ADDENDUM NO. 1

DATE: January 16, 2025
FROM: City of Grand Junction Purchasing Division
TO: All Offerors
RE: Odelberg Drain Replacement IFB-5570-25-DD

GRAND VALLEY DRAINAGE DISTRICT ODELBERG DRAIN REPLACEMENT

PROJECT NO. F210305A

D 1/2 RD, ODELBURG DRAIN ROADWAY DEMOLITION PLANS
DEMOLITION PLAN - 03

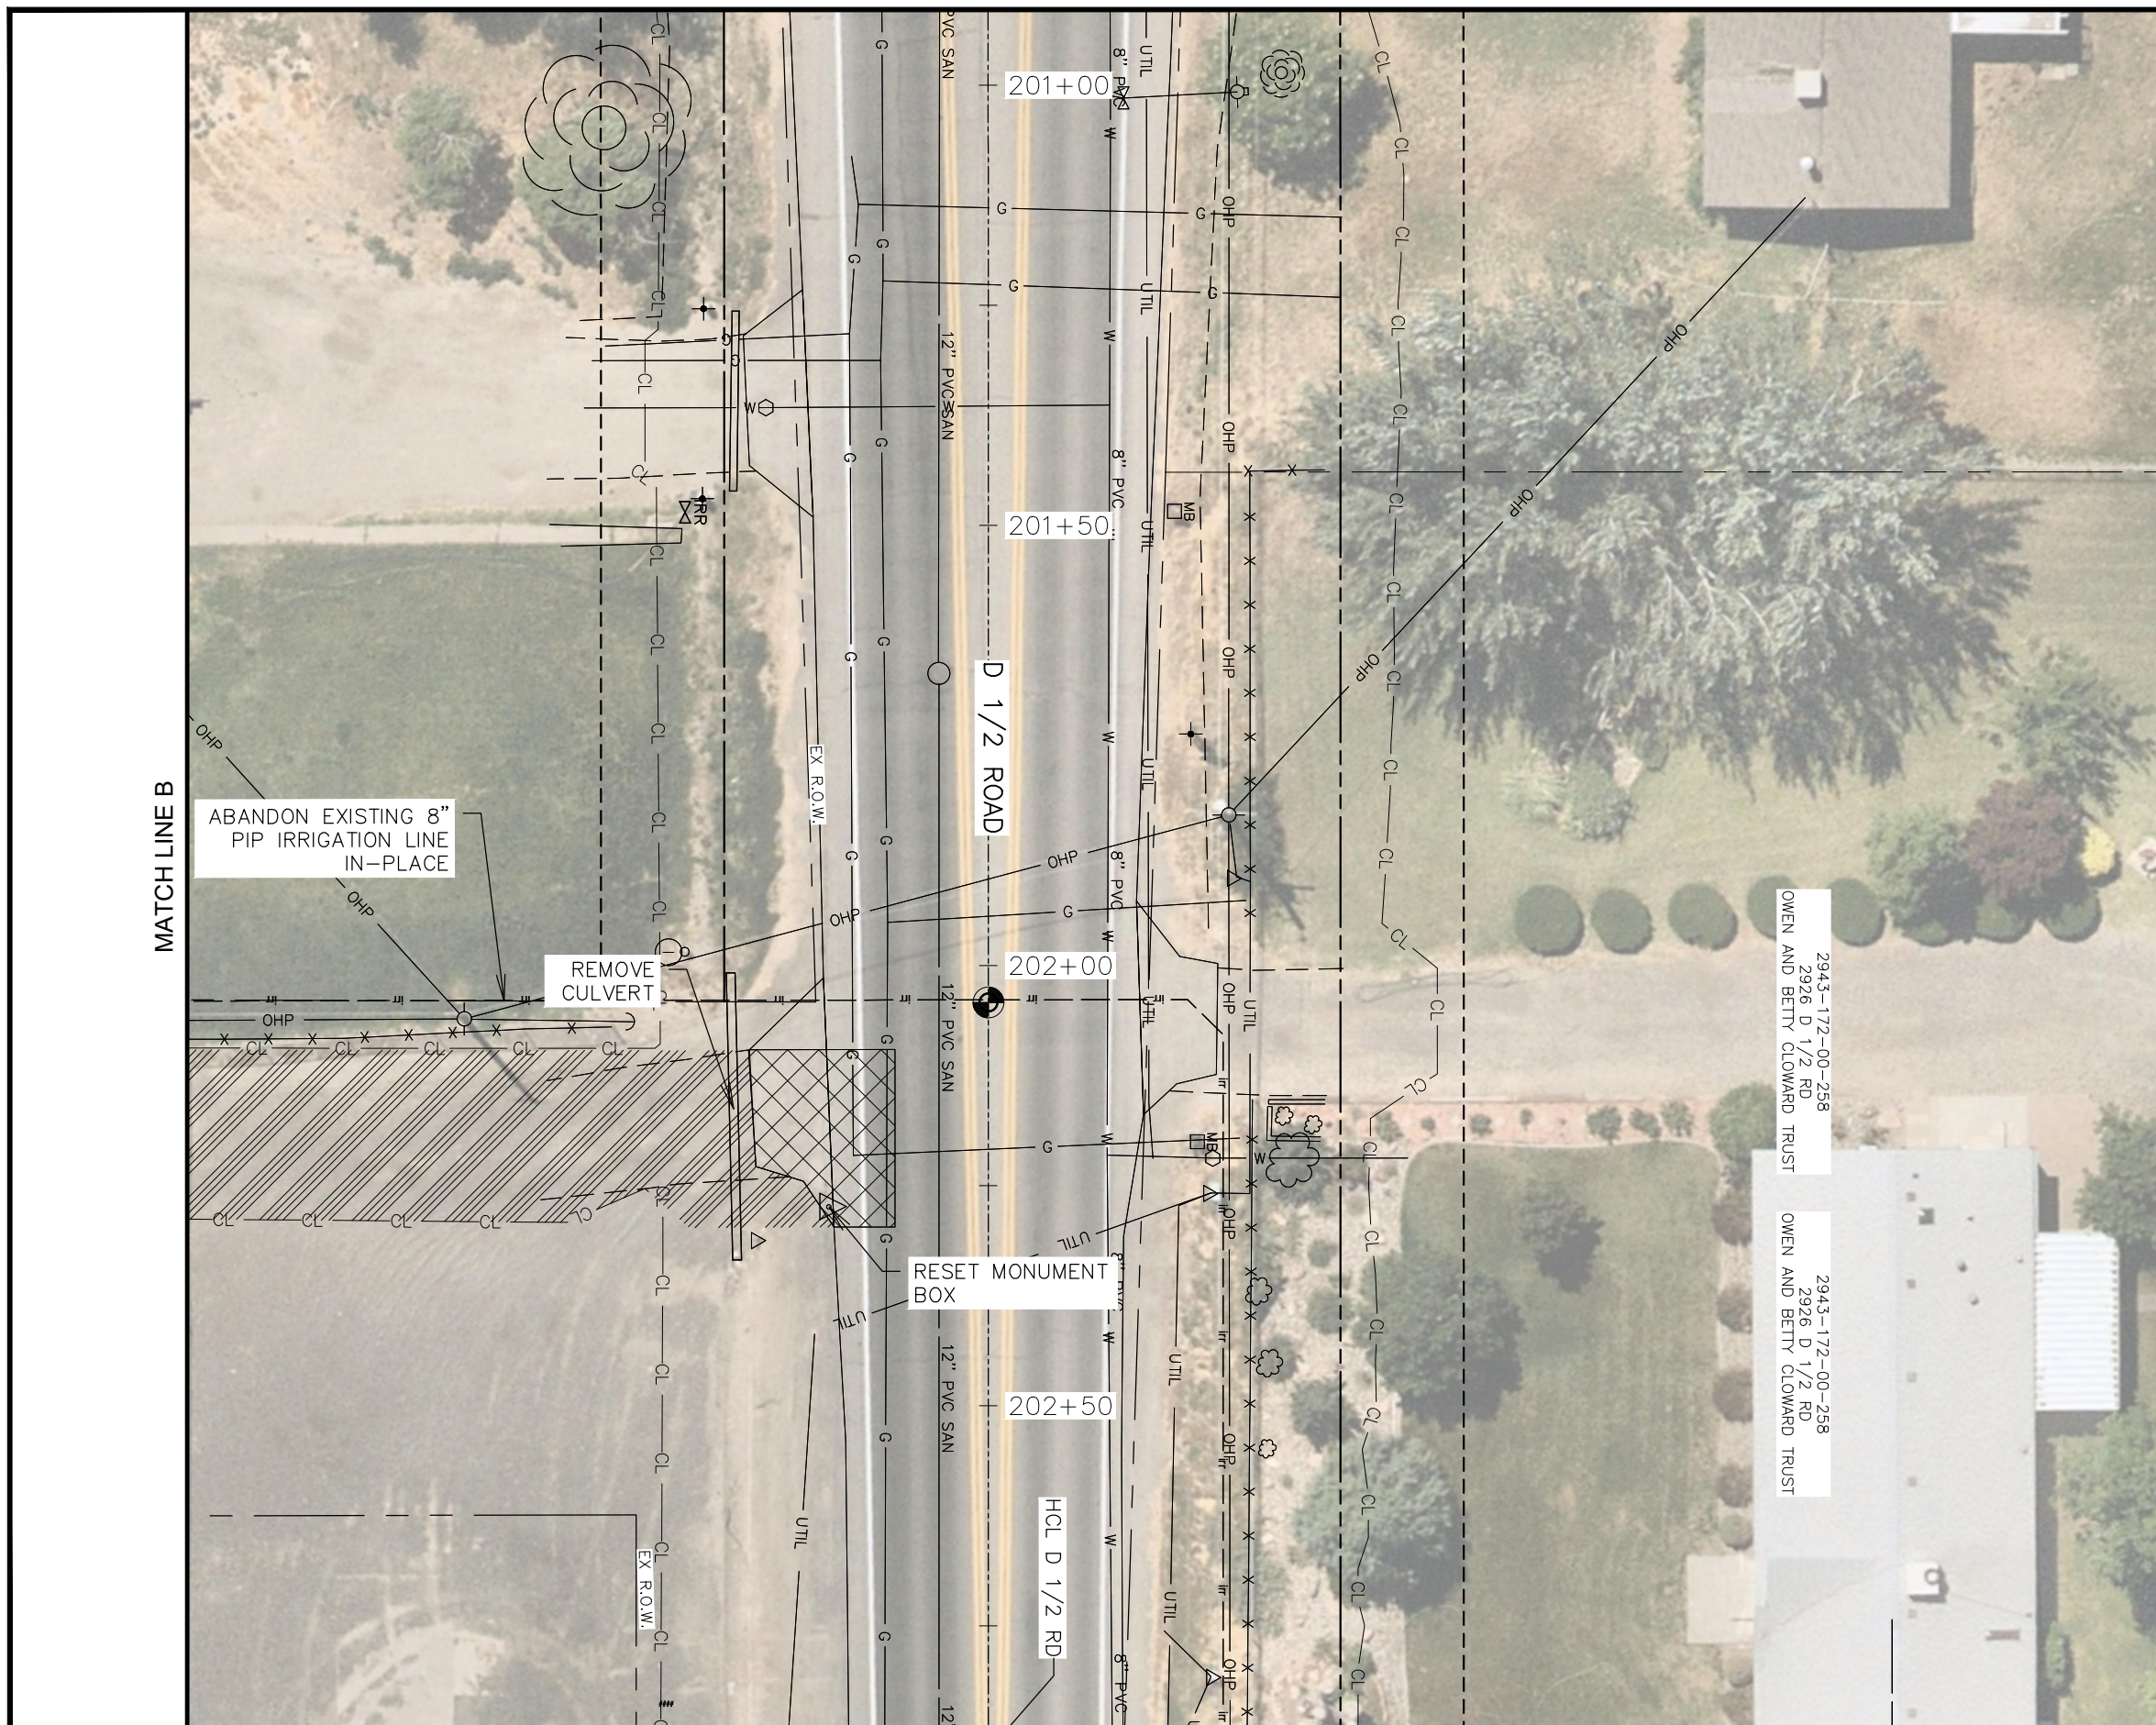
10. Question: On sheet 05 of the plans, there is a "Remove Culvert" callout? What is to be done to restore the culvert if anything?

REMOVE CULVERT

Answer: This project will be stopped short of that culvert. The City intends the stormwater line to be terminated approximately in line with the "Construction Limits" east-west lines to each side of that area. There should be no culvert removal, no reset monument box, and no impacts to the pavement section.

**D 1/2 RD, ODEMBERG DRAIN
DRAINAGE & IRRIGATION PLANS
DRAINAGE PROFILE - 01**

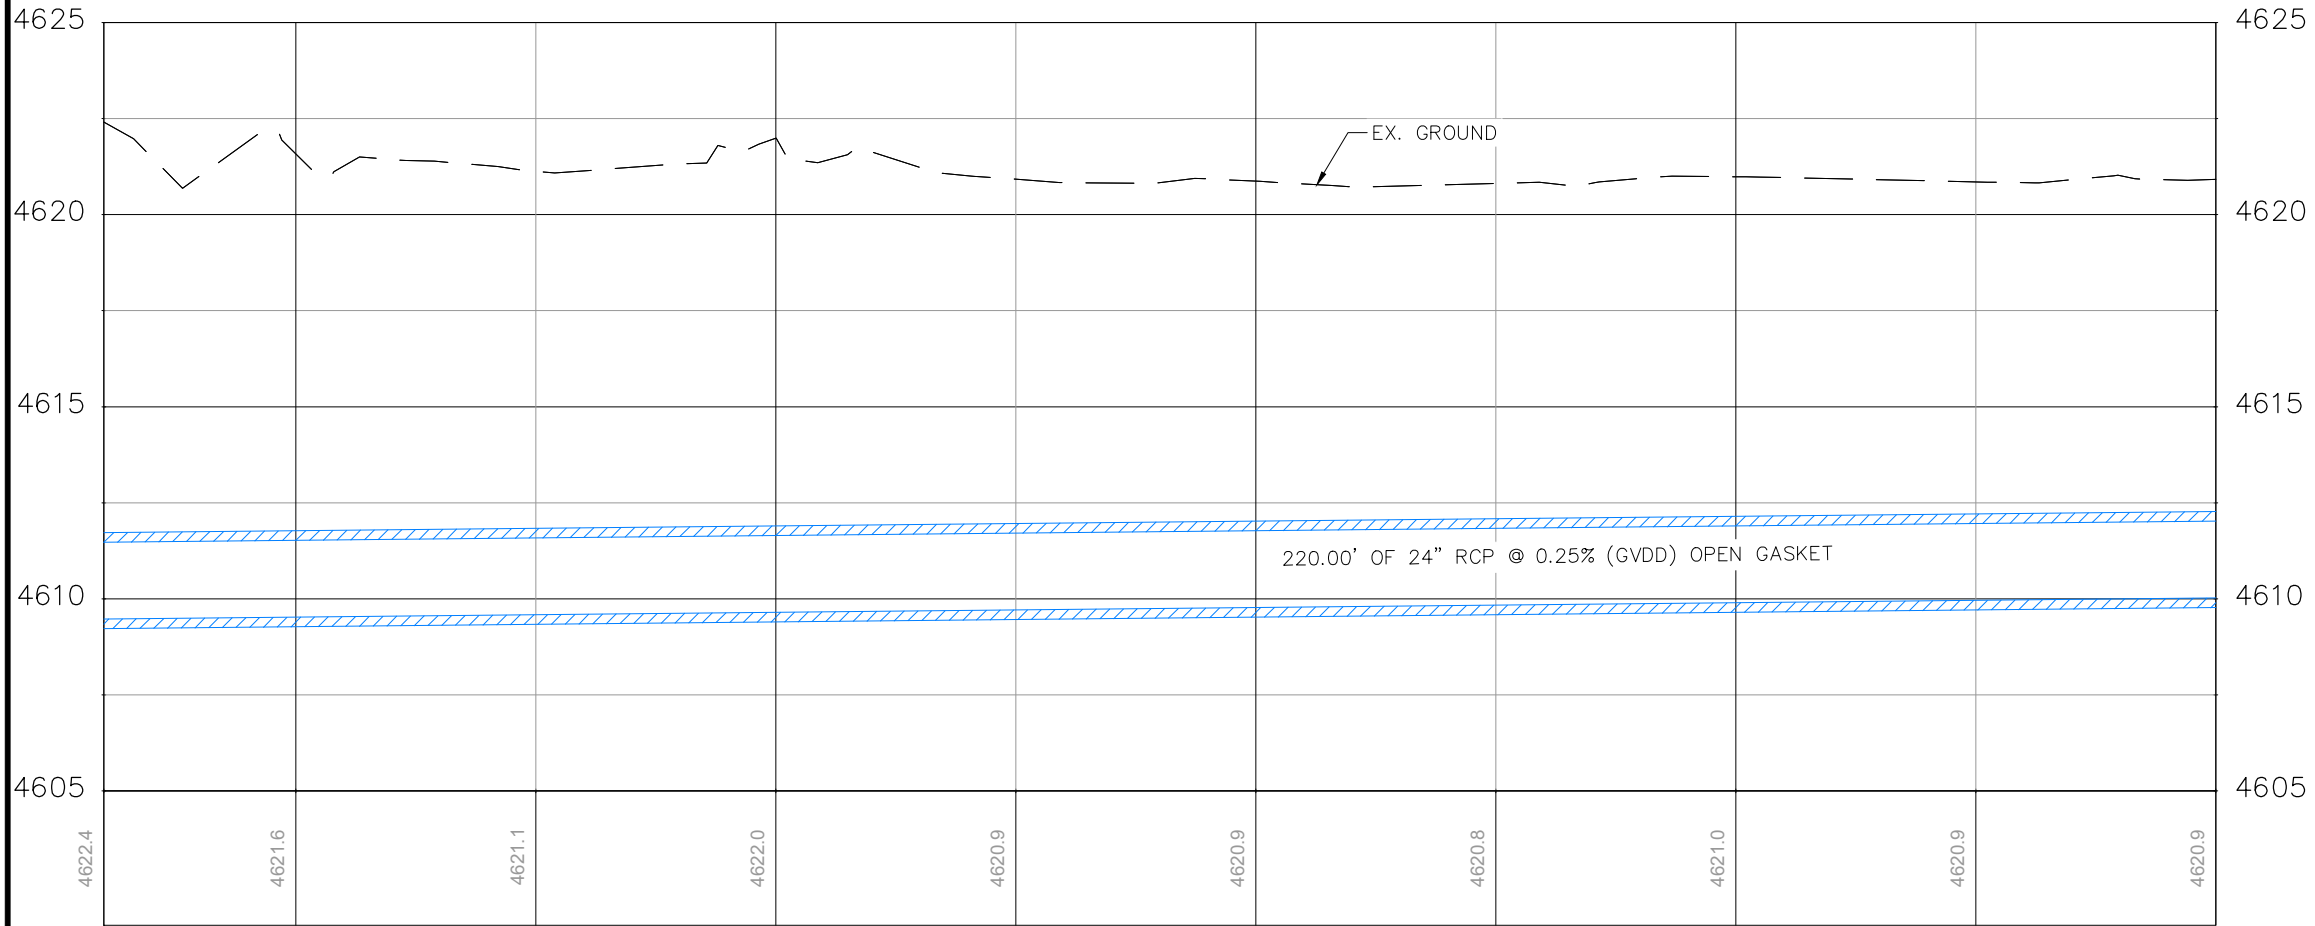
- 1. Question:** The Mesa County Ditch shown on Blueprint Sheet 6 is concrete (gunnite)? Will it need to be replaced in concrete at the crossing?
Answer: GVIC is asking for a shotcrete finish to the canal crossing to match existing. Bid line item has been added to attached revised Bid Schedule.
